To: T10 Technical Committee
From: Rob Elliott, HP (elliott@hp.com)
Date: 4 March 2006
Subject: 05-322r2 SAS-2 Wide port simultaneous connection rules

Suggested changes**7.12.2 Opening a connection****7.12.2.1 Connection request**

Figure 1 — Destination group example (perspective from initiator port)

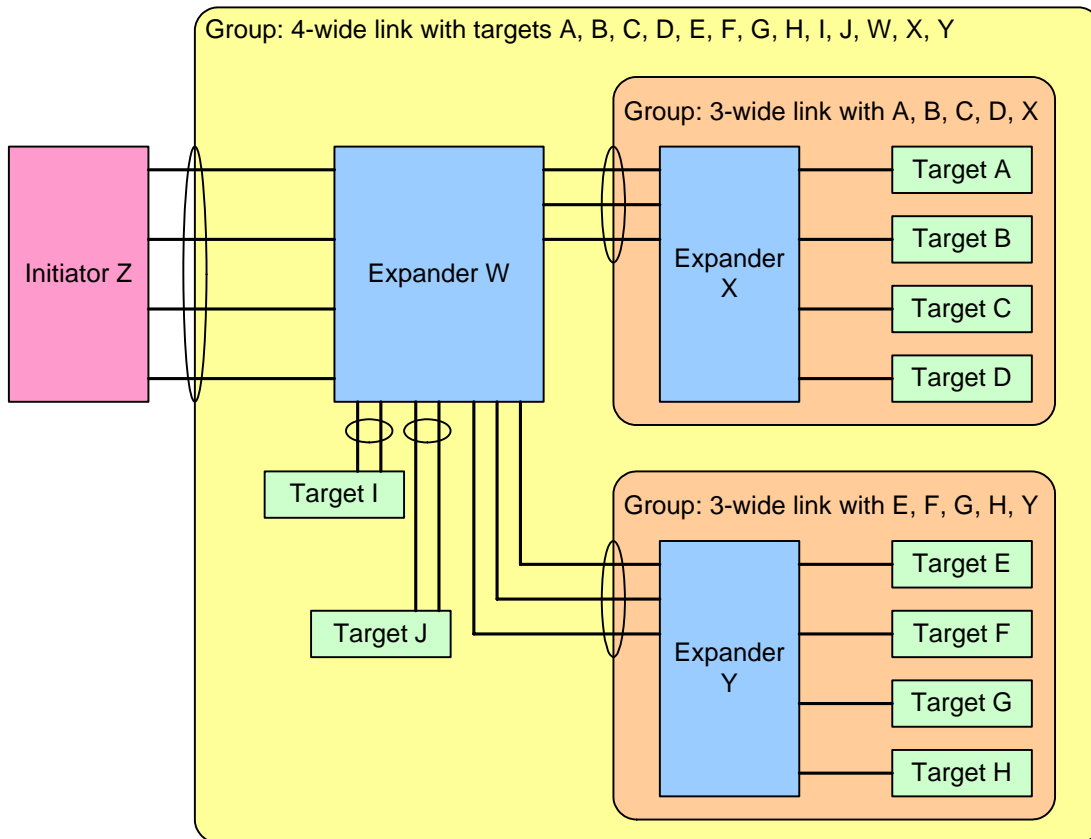
For example, in figure 1, the initiator port considers all the expander devices and target ports to be part of a destination group sharing the 4-wide link. A, B, C, D, and X are in a separate destination group sharing a 3-wide link. E, F, G, H, and Y are in another destination group sharing a 3-wide link. I and J are just in the main destination group (each could be considered part of its own 2-wide destination group as well, if that is a convenient way to keep track of destination port widths).

For example, if Z is connected to A, B, and C, it should not attempt a connection to D (because the 3-wide group to which it is a member is exhausted); instead, it should favor a connection to another destination that does not belong to a group that is exhausted.

Figure 2 — Example simultaneous connection rules for wide SSP ports

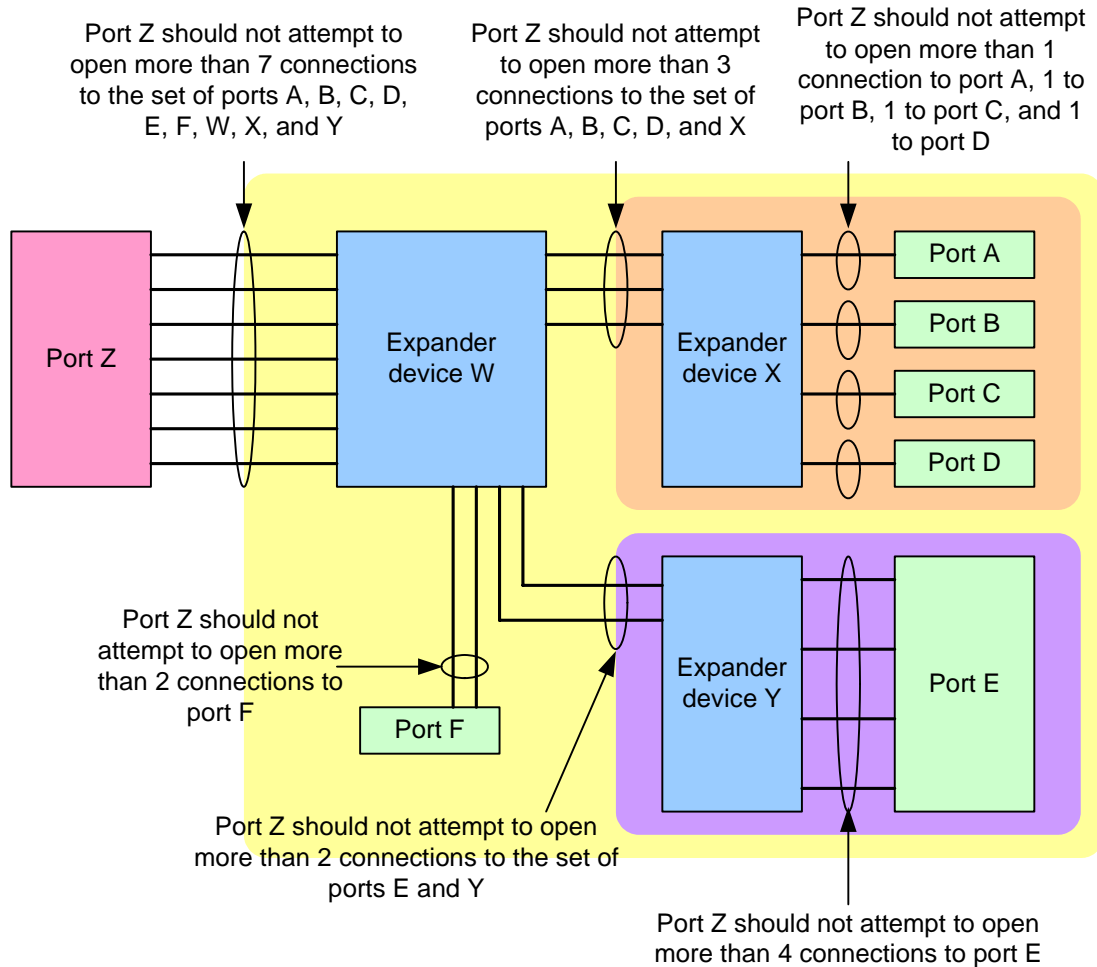
A wide SSP port should not attempt to establish more connections to a destination port than the destination port width or the width of the narrowest physical link on the pathway to the destination port. A wide SSP port should not attempt to establish more connections to a set of destination ports than the width of the narrowest common physical link on the pathways to that set of destination ports.

Figure 2 shows an example of the connection rules for wide SSP ports.

- port Z should not attempt to open more than 2 connections to port E, because the narrowest physical link on the pathway to port E is 2-wide;
- if port Z has 1 connection open to Y, it should not attempt to open more than 1 more connection to expander device Y or port E; and
- if port Z has 1 connection open to port A, 1 to port B, and 1 to port C, it should not attempt to open any connection to expander device X or port D, and should not attempt to open more than 4 connections to the set of E, F, W, and Y.

Figure 3 — Example simultaneous connection rules for STP ports in an expander device

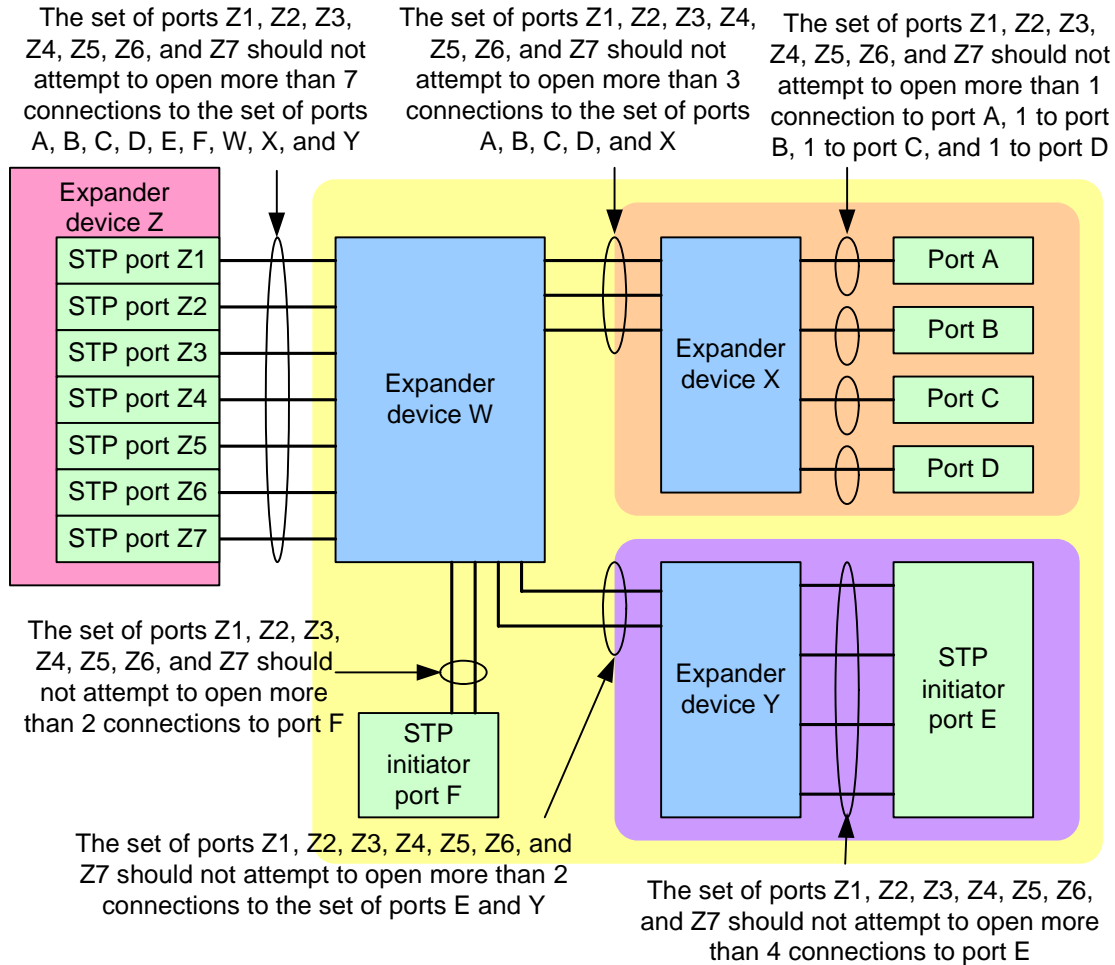
An expander device should not allow its set of STP ports (e.g., the STP target ports in STP/SATA bridges) to attempt to establish more connections to a destination port than the destination port width or the width of the narrowest physical link on the pathway to the destination port.

An expander device should not allow its set of STP ports (e.g., the STP target ports in STP/SATA bridges) to attempt to establish more connections to a set of destination ports than the width of the narrowest common physical link on the pathways to that set of destination ports.

Figure 3 shows an example of the connection rules for STP ports in expander devices.

- a) the set of ports Z1, Z2, Z3, Z4, Z5, Z6, and Z7 should not attempt to open more than 2 connections to port E, because the narrowest physical link on the pathway to port E is 2-wide;
- b) if the set of ports Z1, Z2, Z3, Z4, Z5, Z6, and Z7 has 1 connection open to Y, it should not attempt to open more than 1 more connection to expander device Y or port E; and
- c) if the set of ports Z1, Z2, Z3, Z4, Z5, Z6, and Z7 has 1 connection open to port A, 1 to port B, and 1 to port C, it should not attempt to open any connection to expander device X or port D, and should not attempt to open more than 4 connections to the set of E, F, W, and Y.
